## ADDENDUM NO. 1

**City of Mercer Island, Washington**  
**77<sup>th</sup> Ave SE & Sunset Hwy SE Intersection Improvements**  
**PROJECT NUMBER SP120**

DATE OF ADDENDUM ISSUE: June 23, 2022  
DATE OF BID OPENING: June 30, 2022

**CHANNELIZATION & SIGNING PLAN**

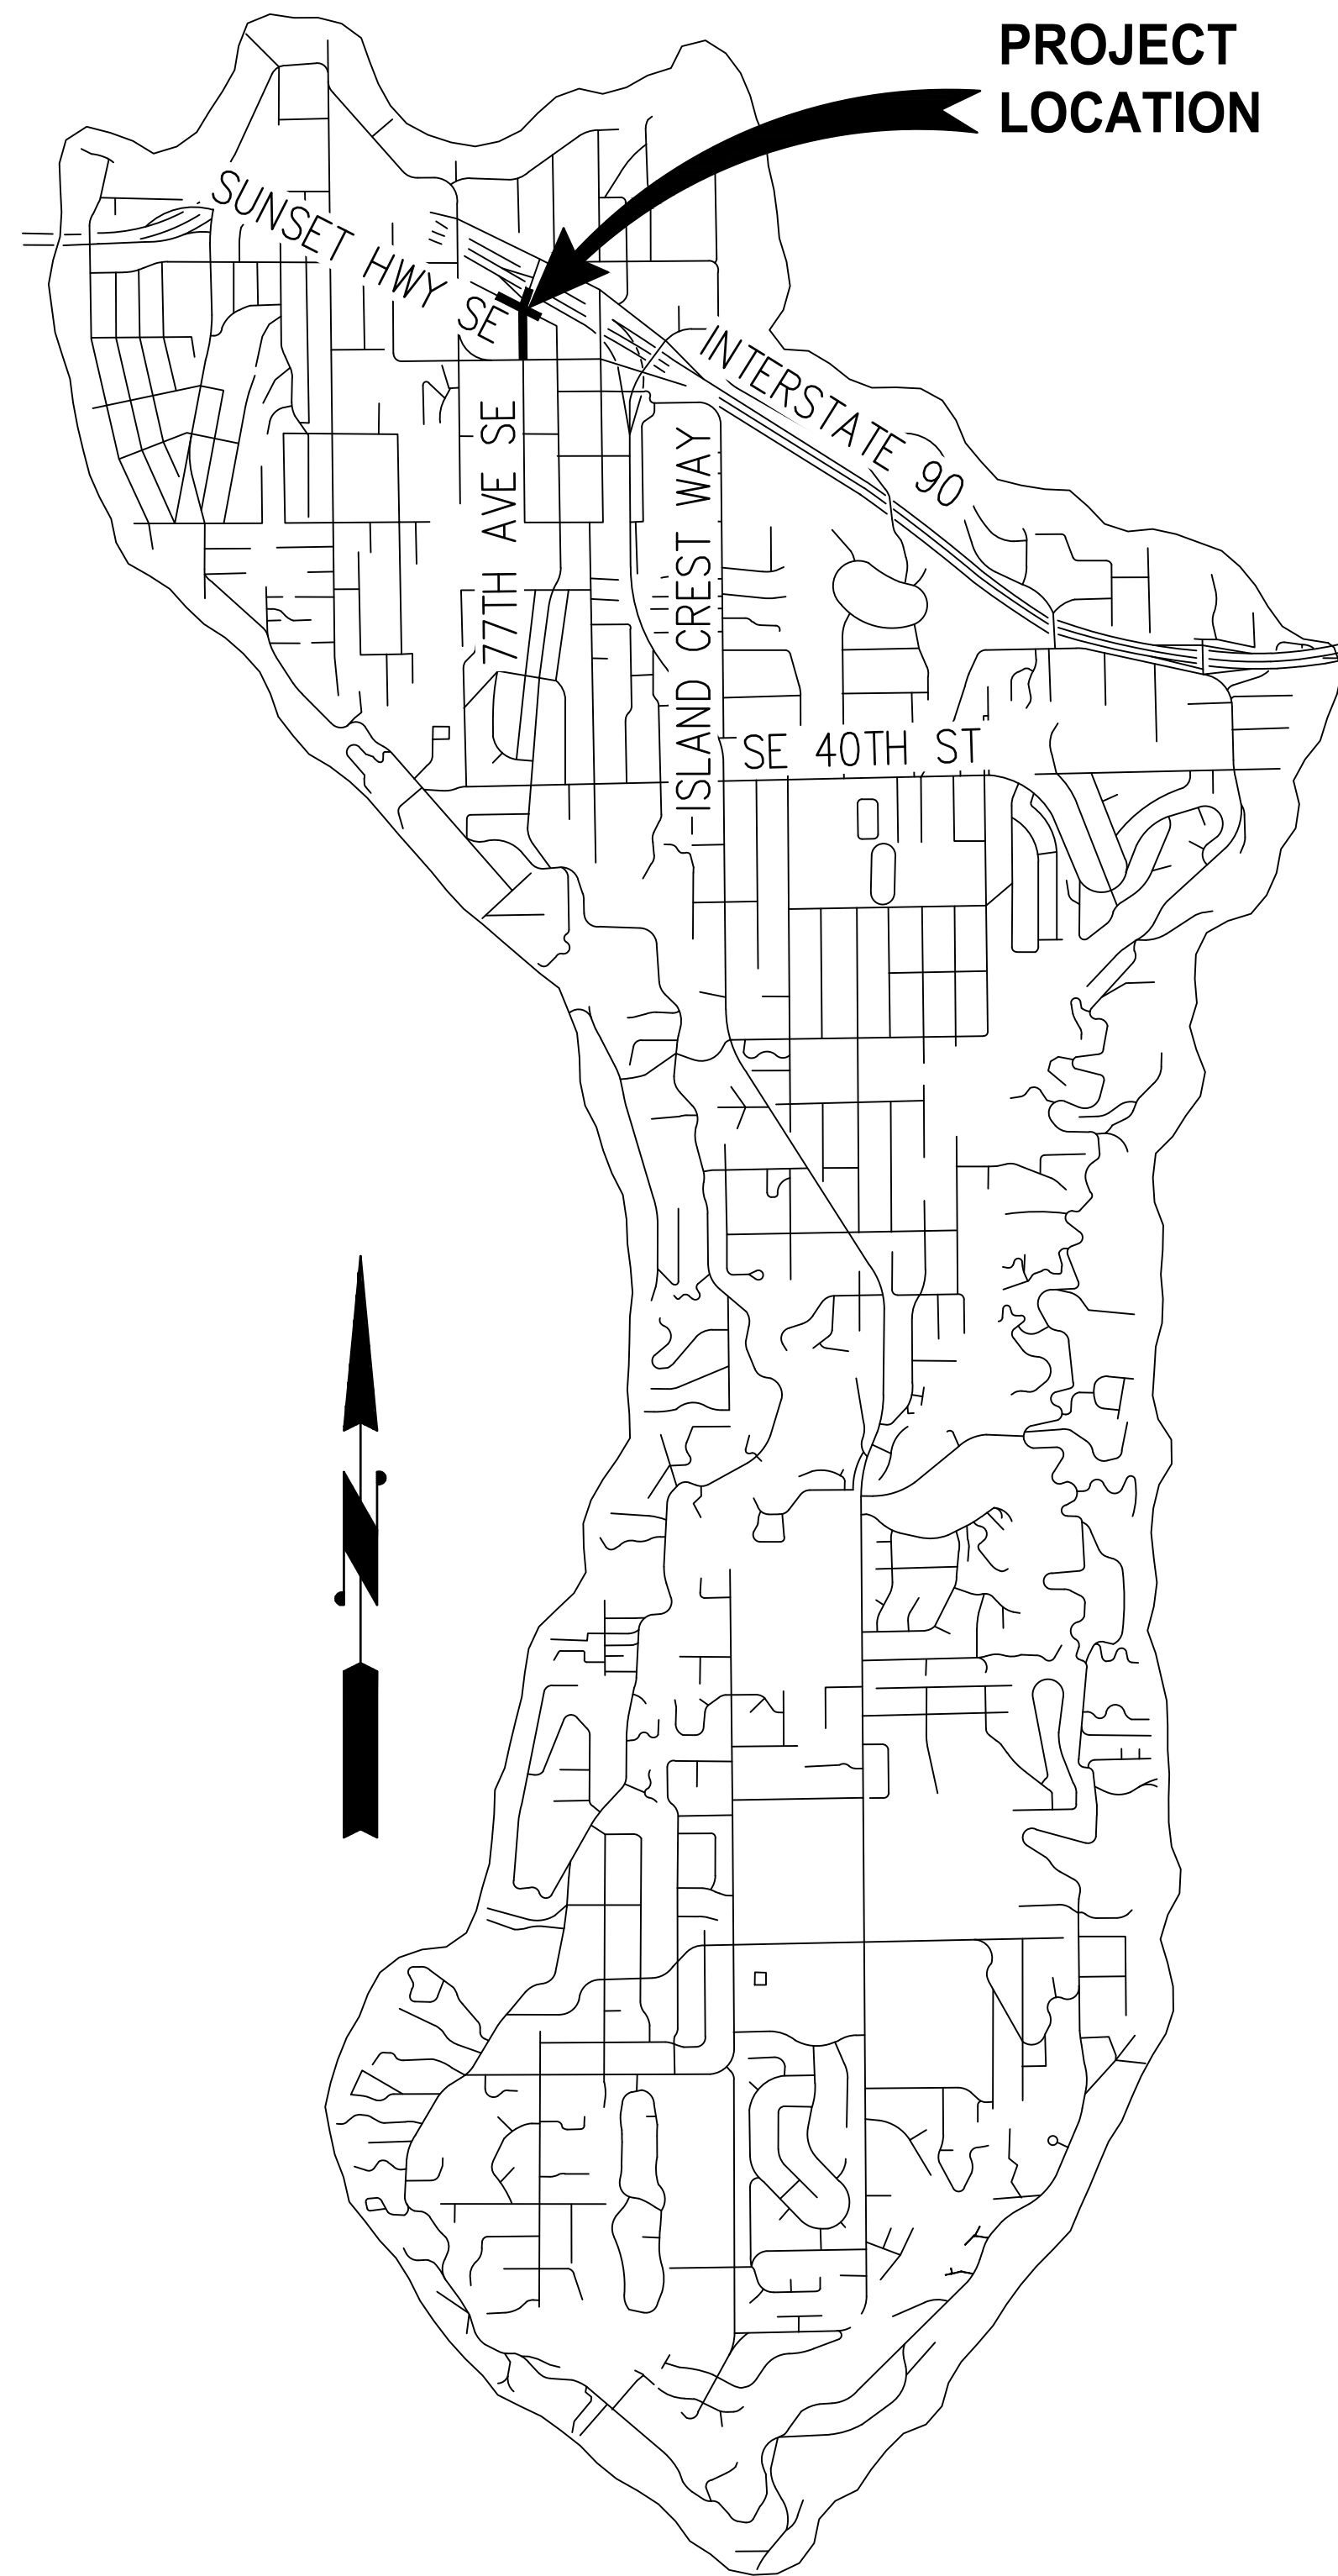
- Page 4: Lane Width Revision
- Page 18: Revision to the Bike Ramp Channelization and addition of detectable warning strip detail
- Page 23: Revision to the Channelization callout and lane widths
- Page 27: Revision to Phase Two and Three General Note 8.
- Page 29 & 30: Addition of note describing one-way flagging operation for Sunset Highway SE west leg.

NO.	DATE	BY	APPR.	REVISIONS
1	6/23/22	BMC	BMC	CHANNELIZATION

**TRAFFIC CONTROL & DETOUR PLANS  
TRAFFIC CONTROL GENERAL NOTES**

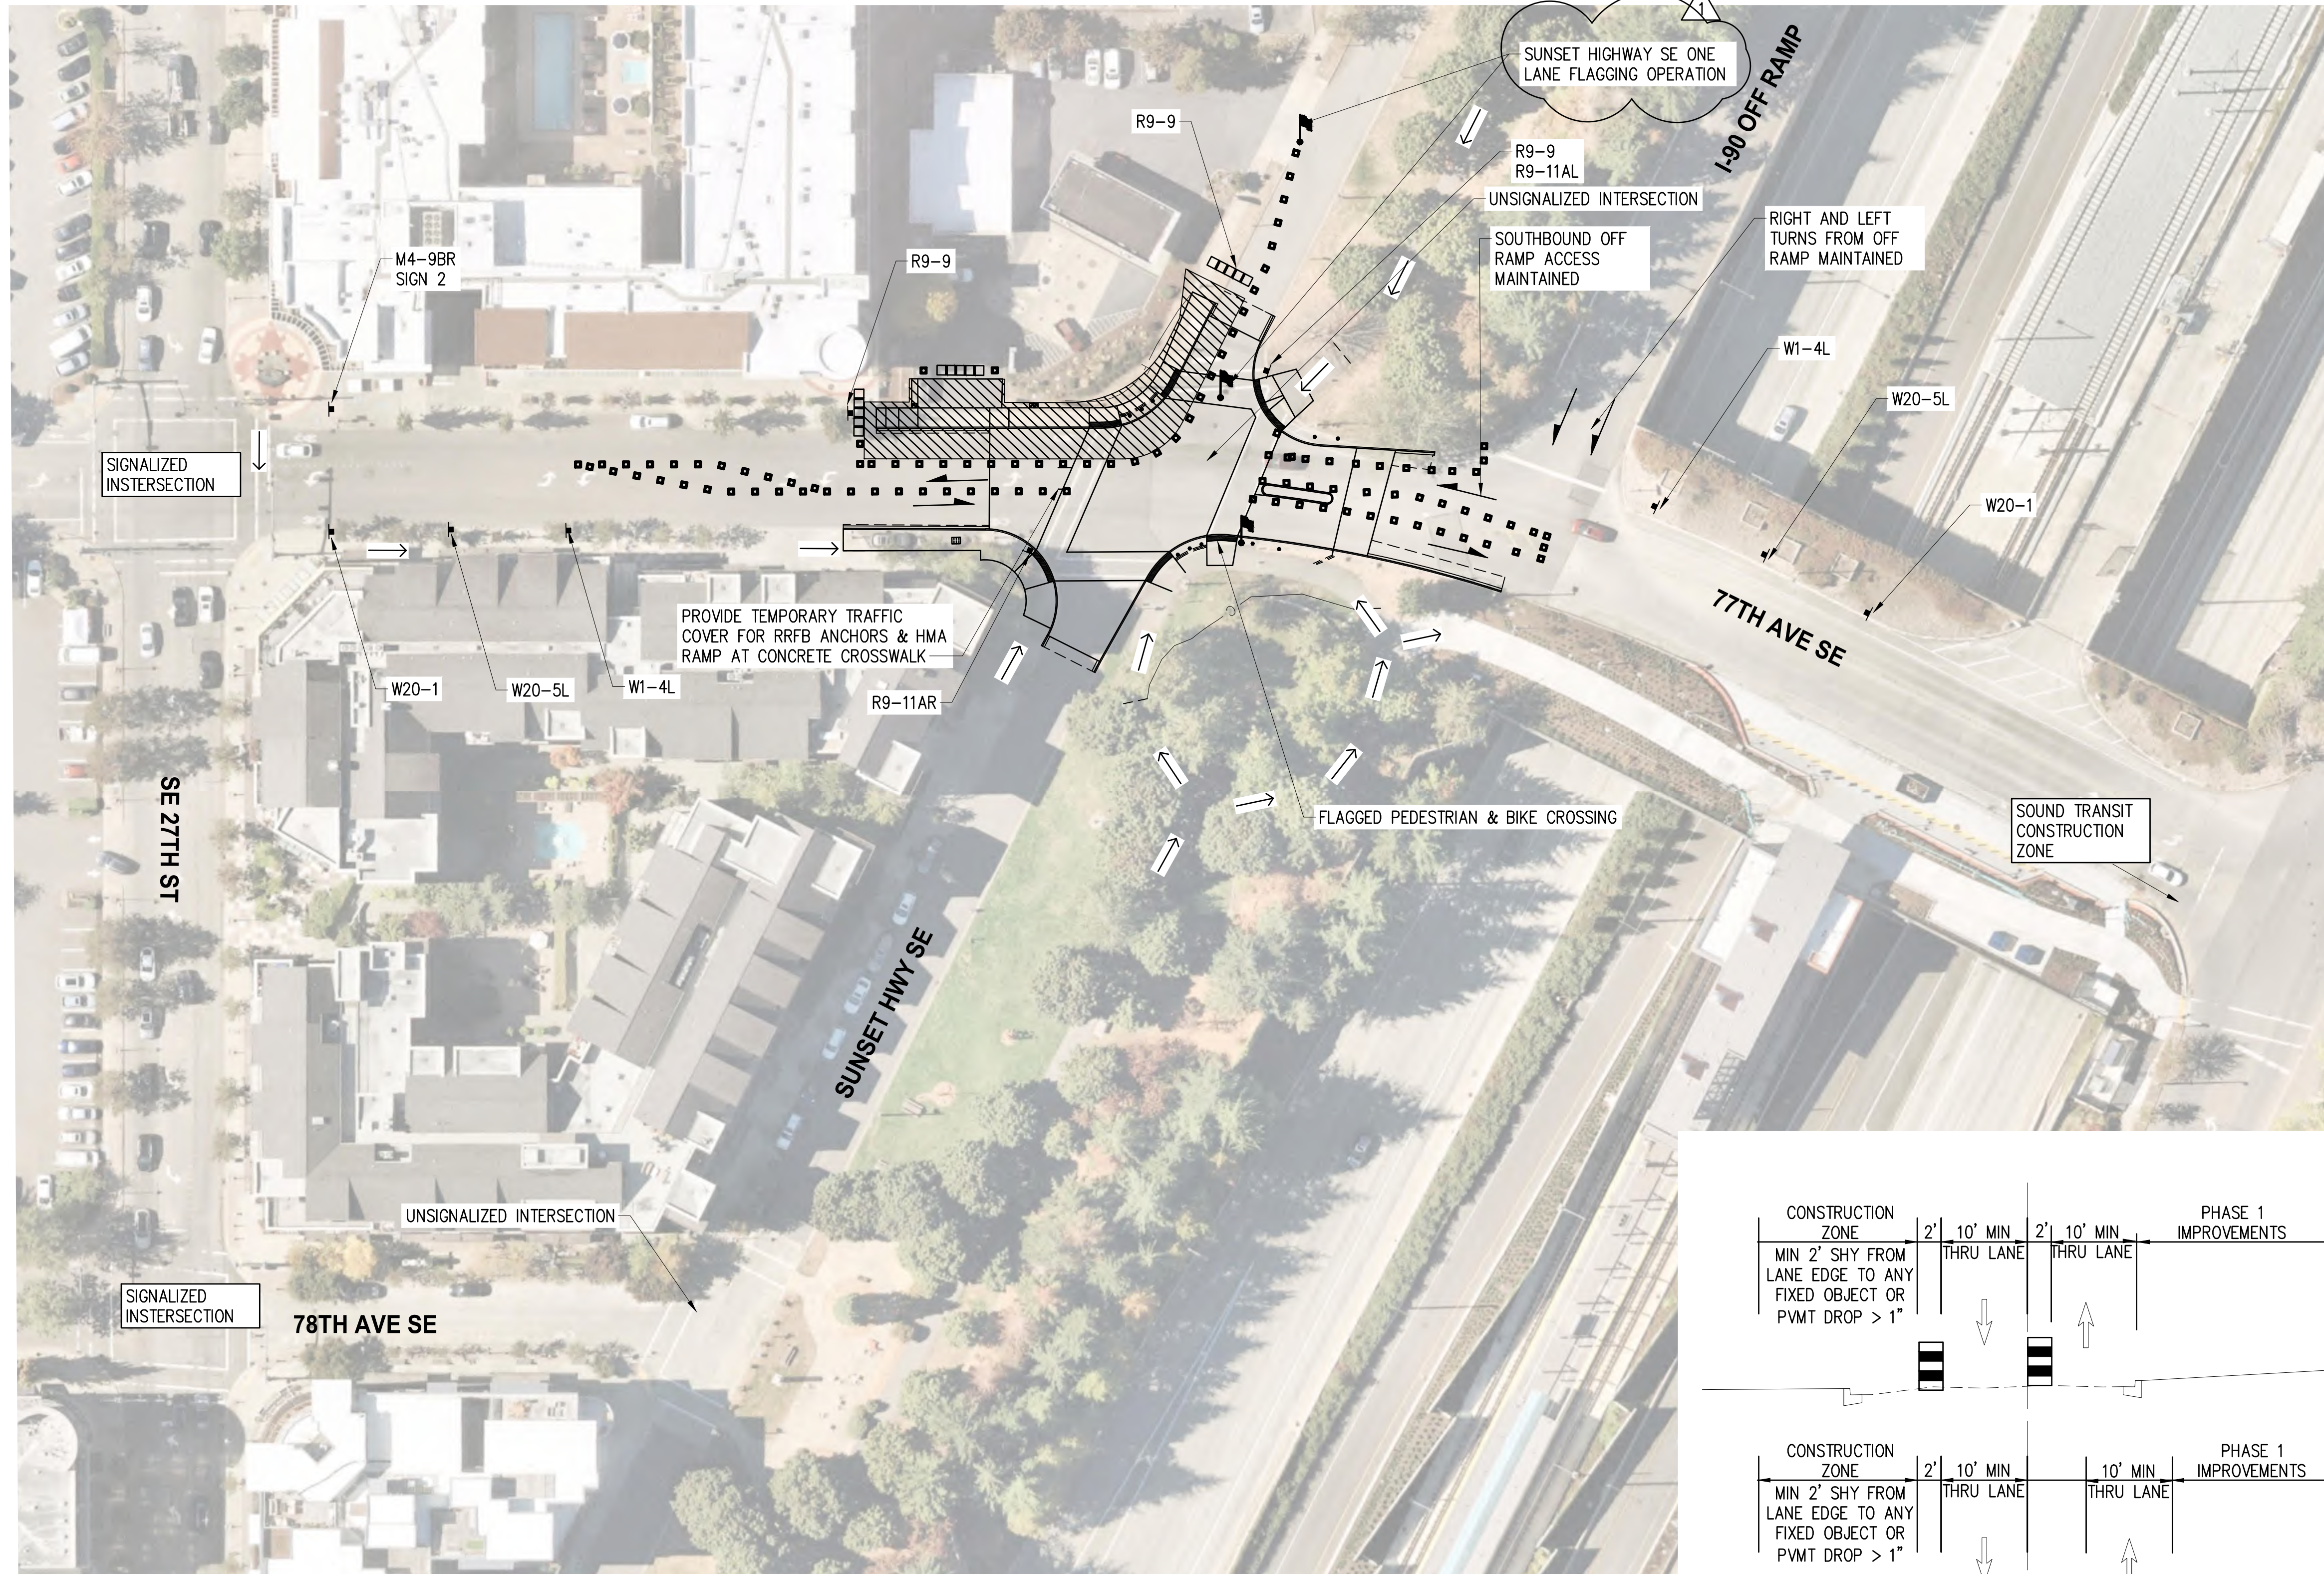
NO.	DATE	BY	APPR.	REVISIONS
1	6/23/22	BMC	BMC	WORK HOUR RESTRICTIONS

7. PHASE ONE: NORTHBOUND 77TH AVE SE TRAFFIC SHALL REMAIN CLOSED FOR DURATION OF PHASE ONE CONSTRUCTION AT THE INTERSECTION. NORTHBOUND ACCESS TO CHEVRON SHALL BE PROVIDED AT ALL TIMES. SOUTHBOUND TRAFFIC SHALL BE MAINTAINED 24 HOURS PER DAY. WEST SEGMENT OF SUNSET HIGHWAY TRAFFIC SHALL HAVE FLAGGER CONTROLLED ACCESS. TWO WAY ACCESS SHALL BE PROVIDED WHILE CONTRACTOR IS ON SITE. RIGHT-IN, RIGHT-OUT SHALL BE PROVIDED WHILE CONTRACTOR IS OFFSITE. EAST SEGMENT SUNSET HIGHWAY SHALL BE CLOSED AT THE INTERSECTION. DRIVEWAY/GARAGE ACCESS SHALL BE MAINTAINED TO ADJACENT BUILDING.

8. PHASES TWO AND THREE: WEST SEGMENT OF SUNSET HIGHWAY ONE-WAY TRAFFIC SHALL ONLY BE ALLOWED WHILE CONTRACTOR IS ON SITE AND DURING CROSSWALK INSTALLATION. PROVIDE FOR TWO-WAY TRAFFIC DURING CONSTRUCTION OFF HOURS. NO TEMPORARY STOPPAGE OF SOUTHBOUND TRAFFIC WILL BE ALLOWED FROM 7:30AM-9AM AND 300PM-6PM. SHOULD ANY TEMPORARY STOPPAGE OF SOUTHBOUND TRAFFIC OCCUR DURING THE HOURS OF 9AM-3PM IMPACT THE 77TH AVE SE OFF RAMP, THE CONTRACTOR SHALL CLEAR TRAFFIC IMMEDIATELY. FURTHER TRAFFIC CONTROL RESTRICTIONS MAY BE REQUIRED SHOULD 77TH AVE SE OFF RAMP OPERATIONS BE IMPACTED.

**TEMPORARY TRAFFIC CONTROL TYPICAL SECTION**  
NTS

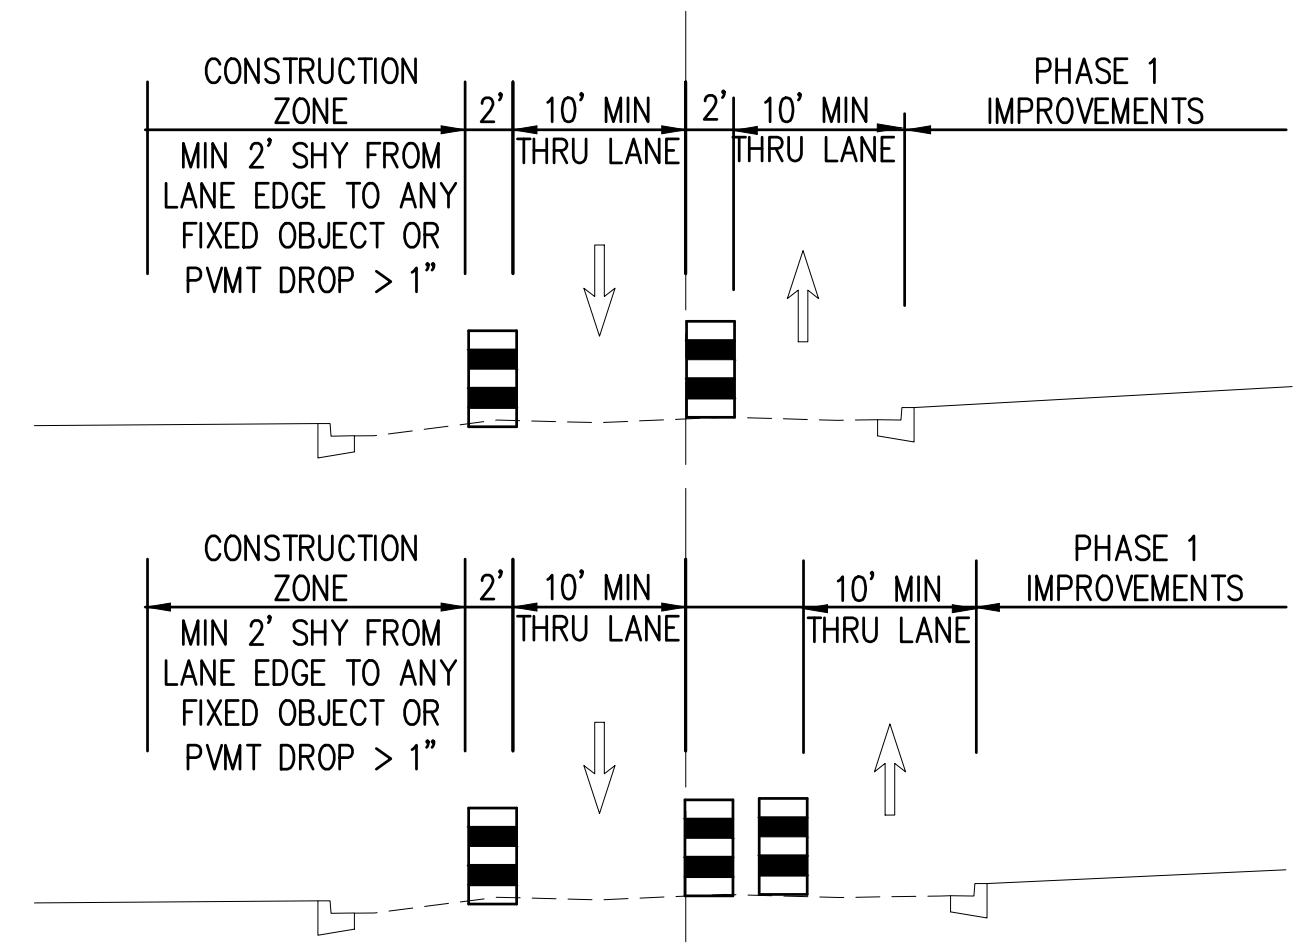
NO.	DATE	BY	APPR.	REVISIONS
1	6/23/22	BMC	BMC	FLAGGING CLARIFICATION

Phases Two and Three: west segment of sunset highway one-way traffic shall only be allowed while contractor is on site and during crosswalk installation. Provide for two-way traffic during construction off hours. No temporary stoppage of southbound traffic will be allowed from 7:30am-9am and 300pm-6pm. Should any temporary stoppage of southbound traffic occur during the hours of 9am-3pm impact the 77th Ave SE off ramp, the contractor shall clear traffic immediately. Further traffic control restrictions may be required should 77th Ave SE off ramp operations be impacted.
